Re: Riverside Station Redevelopment – Peer Review Response to Stormwater Comments

On behalf of our client, Mark Development, we respectfully submit the following responses to comments provided by the Horsley Witten Group, Inc. (HW) in a letter dated January 16, 2020 regarding the Riverside Station Stormwater Peer Review. For clarity, the peer review comments have been repeated in italics preceding each response in bold type.

Figure 7.3.1
Proposed Green Infrastructure

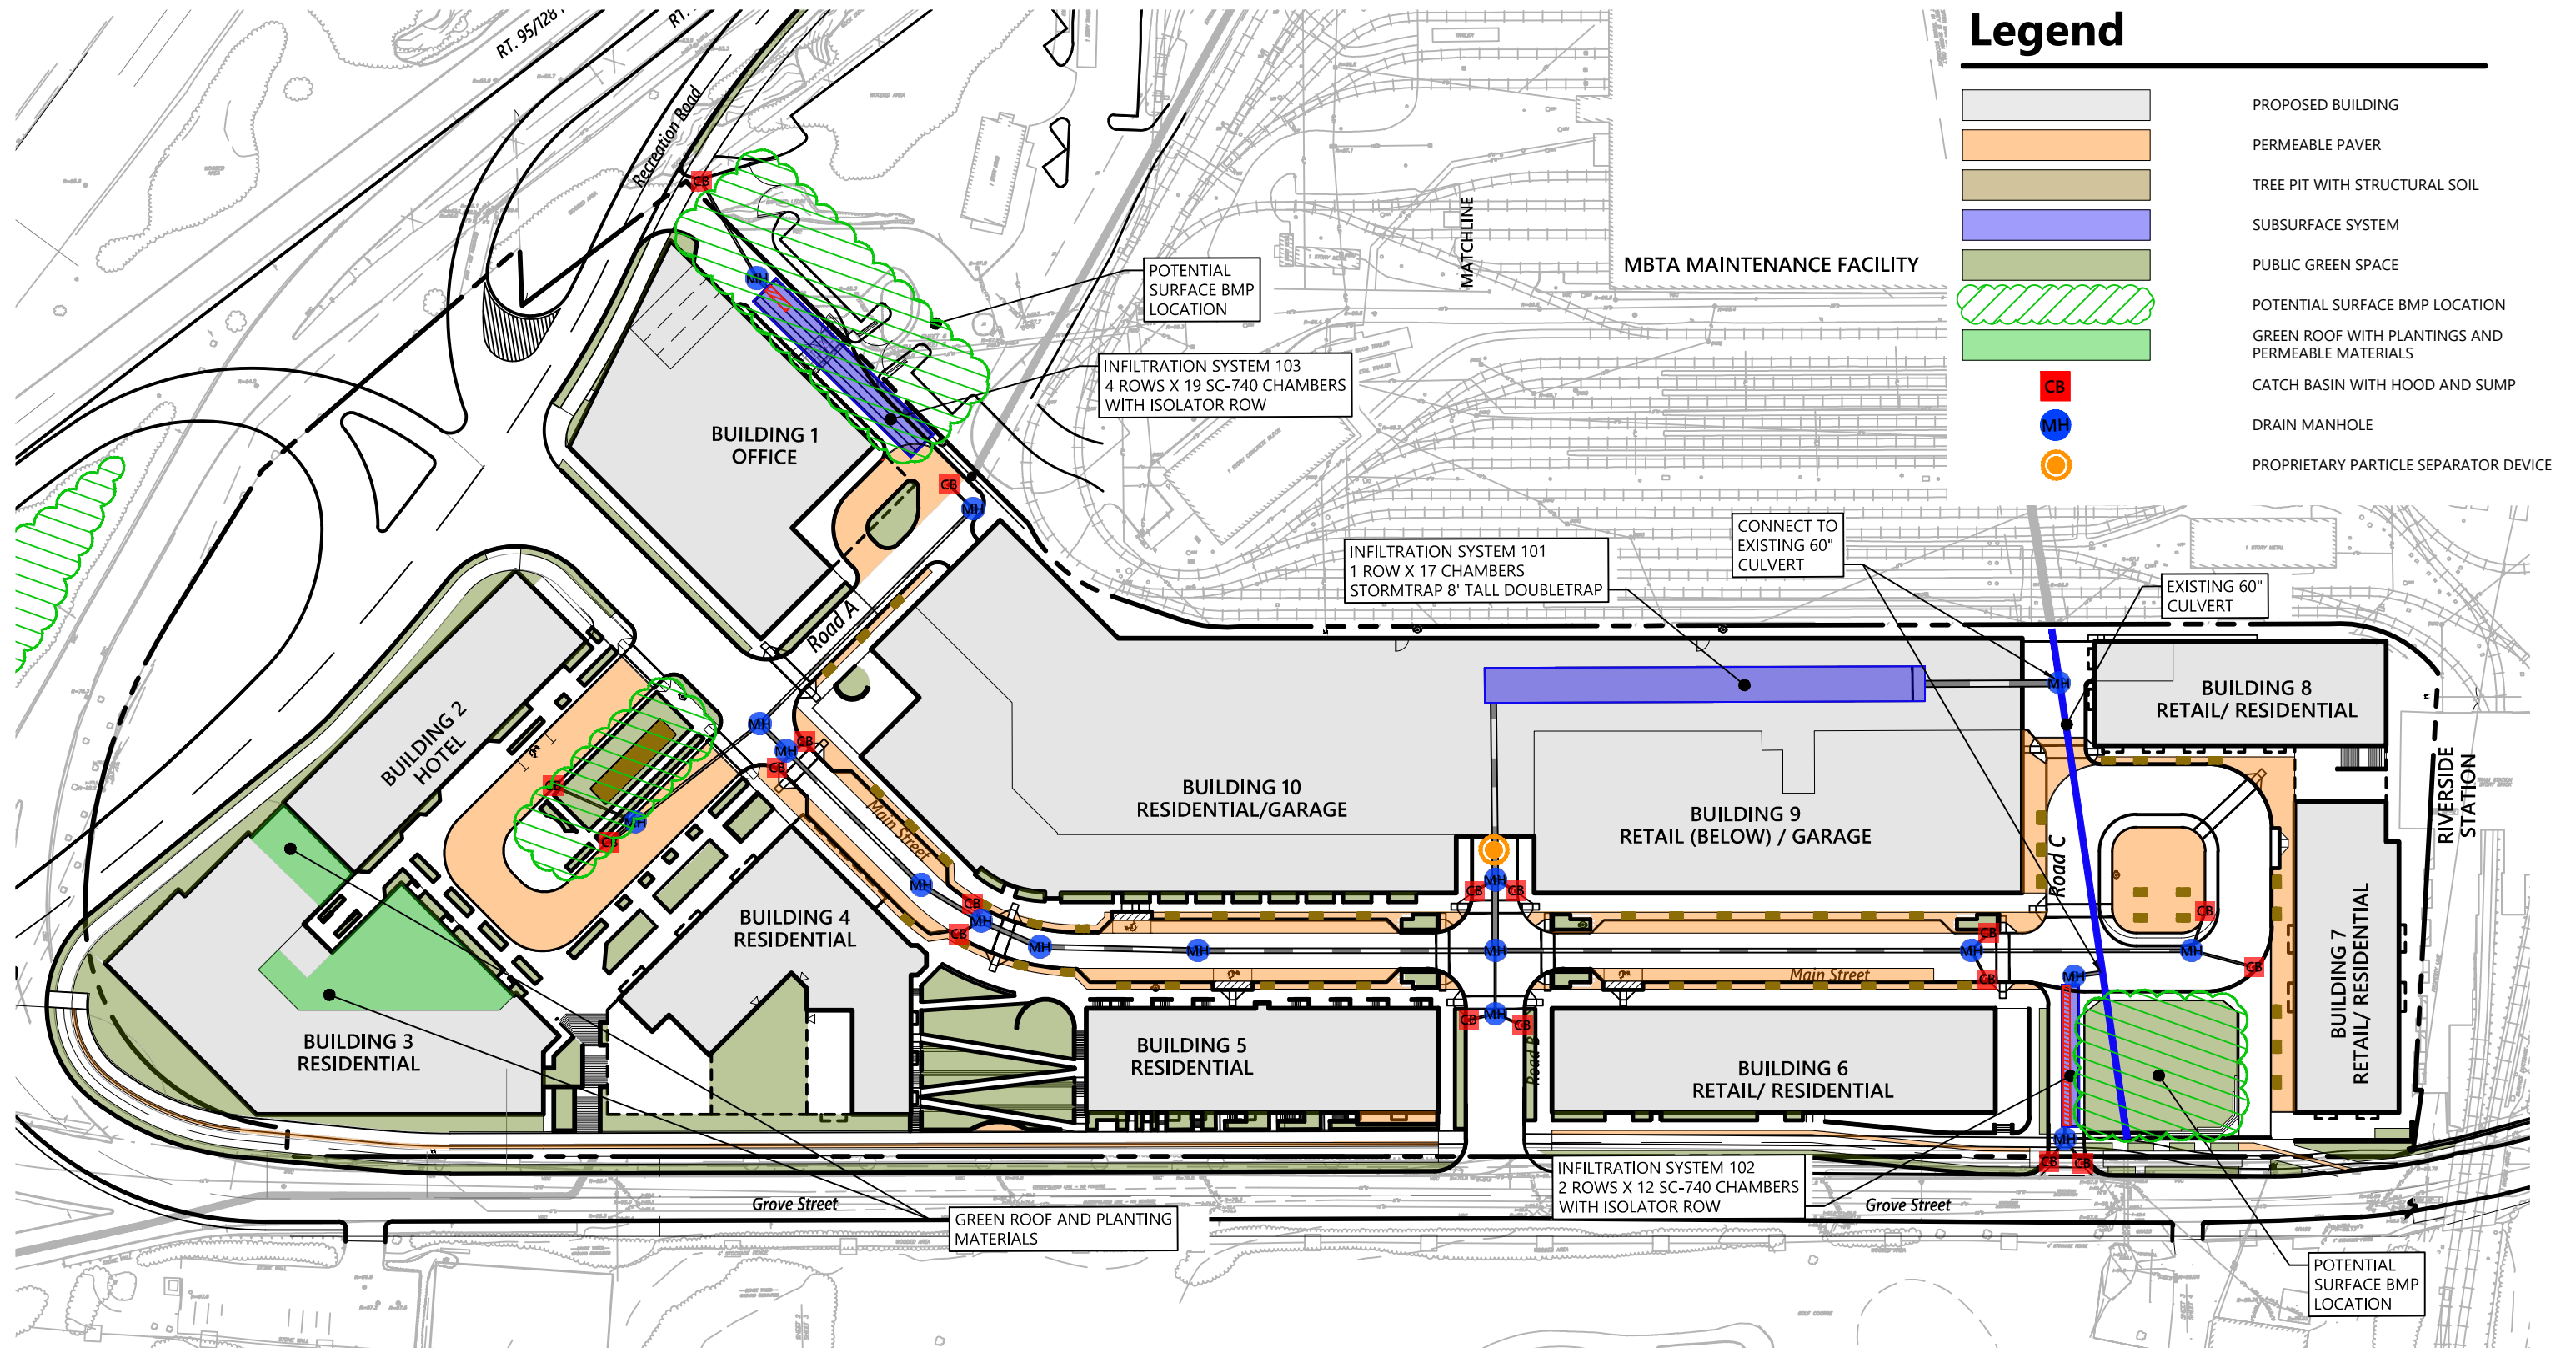
3. *The Applicant is proposing three subsurface infiltration systems to recharge stormwater beneath the site. HW recommends that the Applicant investigate other opportunities to implement green infrastructure within the project limits, including:*

- *Bioretention basins, planters and curb bump-outs*
- *Permeable pavement*
- *Street trees with sand based structural soil*
- *Cisterns to enable rainwater harvesting*
- *Reducing impervious surfaces*
- *Increasing the tree canopy to reduce the heat island effect*
- *Landscape with drought resistant plants*

The Project will restore the ecological and hydrologic functions that have been lost due to an expansive paved parking area and bus depot while adopting best practices and principles of green infrastructure consistent with MassDEP regulations and the City of Newton Street Guide. The design team has developed a green infrastructure concept design that will exceed stormwater management regulatory requirements while creating public amenities, reducing urban heat island effect, enhancing natural habitat and reconnecting Newton residents to Charles River Basin. Sustainability, livability and resilience are used as guiding principles used throughout the design.

The Project's green infrastructure approach will integrate small-scale, decentralized stormwater practices throughout the site, in locations where those practices best fit site conditions and can generate the highest benefits. The proposed green infrastructure practices include water-receiving landscapes, permeable hardscapes and water conservation practices.

1. **Prioritize infiltration facilities where conditions are most amenable. Infiltration facilities maximize groundwater recharge and phosphorus reduction.**
2. **Divert runoff from sidewalks, bike path, and streets into permeable pavement and recharge facilities and bioretention areas integrated into the streetscape and transportation design.**
3. **Capture portions of the roof runoff in rainwater cisterns, to be used for landscape irrigation.**
4. **Maximize tree canopy, and support tree health by extending sand-based structural soil under the sidewalk adjacent to tree wells.**
5. **Design with maintenance and longevity in mind.**
6. **Reduce runoff volume and peak discharge rates to the municipal drainage system.**
